[Docket No. 2003-CE-43-AD; Amendment 39-13328; AD 2003-20-10]

Airworthiness Directives; Raytheon Aircraft Company Beech Models 1900, 1900C, and 1900D Airplanes

ACTION: Final rule; request for comments.

Figure 1

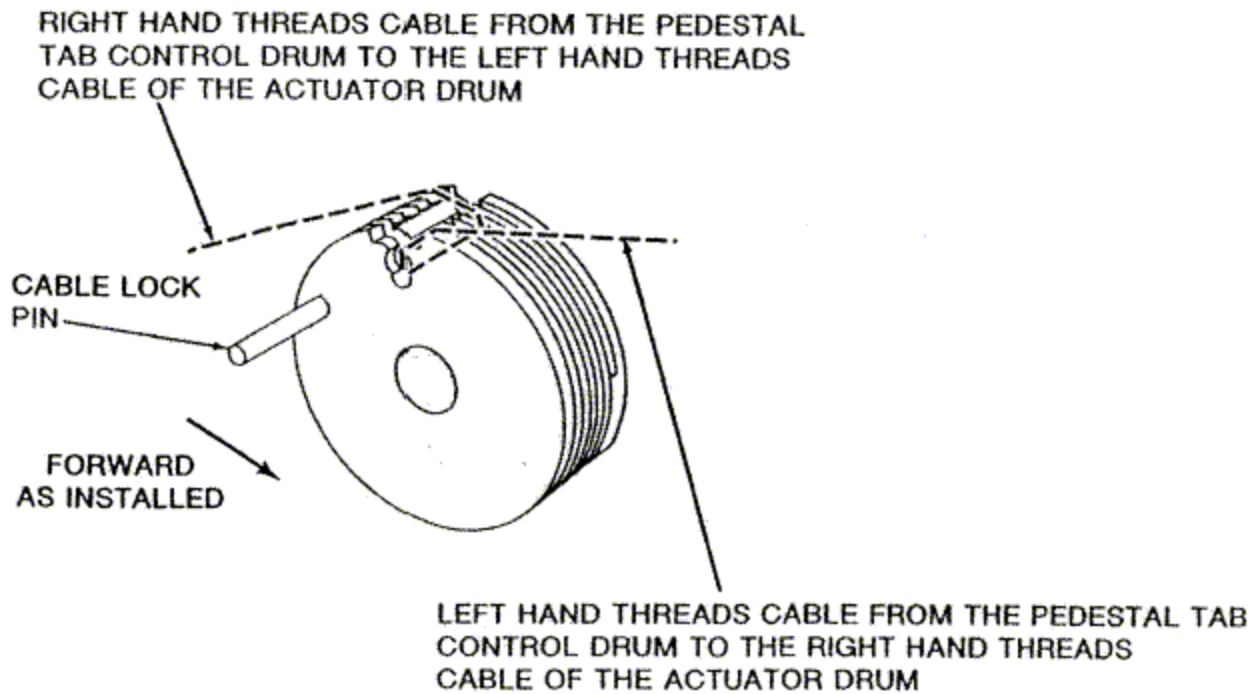
- The figures in the applicable maintenance manuals depict the elevator trim cable drum at 180 degrees from the installed position and show the open, keyed side of the drum instead of the flat side of the drum. Following these figures when installing the control cables on the forward control cable drum could reverse the action of the elevator manual trim system; and
- The existing procedure can be enhanced by visually confirming the trim wheel position and the trim tab position are consistent. Such a check would detect and correct any problems with the elevator trim system installation before problems occur during operation.

Actions	Compliance	Procedures
<p>(1) Using pen and ink, mark the applicable figure in the maintenance manual as referenced below. The depiction in the referenced figures is incorrect for the elevator trim drum only and depicts the cable drum at 180 degrees from the installed position and shows the open, keyed side of the drum instead of the flat side of the drum. Insert corrected figure (Figure 1 of this AD) into the applicable maintenance manual and identify it accordingly:</p> <p>(i) Figure 9 of Chapter 27–10–00 of the Model 1900/1900C Airliner Maintenance Manual (114–590021–7B) Clearly note in pen that existing portion of Figure 9 is correct for the aileron trim drum only and insert corrected figure (Figure 1 of this AD) marked in pen as correct for the elevator trim drum only; or</p> <p>(ii) Mark out Figure 201 of Chapter 27–30–04 of the Model 1900D Airliner Maintenance Manual (125–590000–15). Insert corrected figure (Figure 1 of this AD)</p>	<p>Before the next time you have maintenance done on the elevator trim system.</p>	<p>As specified in Raytheon Safety Communiqué No. 234, dated September 2003.</p>

<p>(2) Incorporate the applicable temporary revision into the maintenance manuals as follows:</p> <p>(i) Temporary Revision No. 27–5 to the Model 1900/1900C Airliner Maintenance Manual: Revised ELEVATOR TRIM OPERATIONAL CHECK; or</p> <p>(ii) Temporary Revision No. 27–9 to the Model 1900D Airliner Maintenance Manual: Added MANUAL ELEVATOR TRIM OPERATIONAL CHECK.</p>	<p>Before the next time you have maintenance done on the elevator trim system.</p>	<p>As specified in Raytheon Safety Communiqué No. 234, dated September 2003.</p>
<p>(3) Do the elevator trim operational check that is specified in the applicable maintenance manual and temporary revisions to the maintenance manual as referenced in paragraph (e)(2) of this AD</p>	<p>Prior to further flight after each time you have maintenance done on the elevator trim system.</p>	<p>As specified in Raytheon Safety Communiqué No. 234, dated September 2003; and Temporary Revision No. 27–5 to the Model 1900/1900C Airliner Maintenance Manual: Revised ELEVATOR TRIM OPERATIONAL CHECK; or Temporary Revision No. 27–9 to the Model 1900D Airliner Maintenance Manual: Added MANUAL ELEVATOR TRIM OPERATIONAL CHECK, both dated September 12, 2003, as applicable.</p>
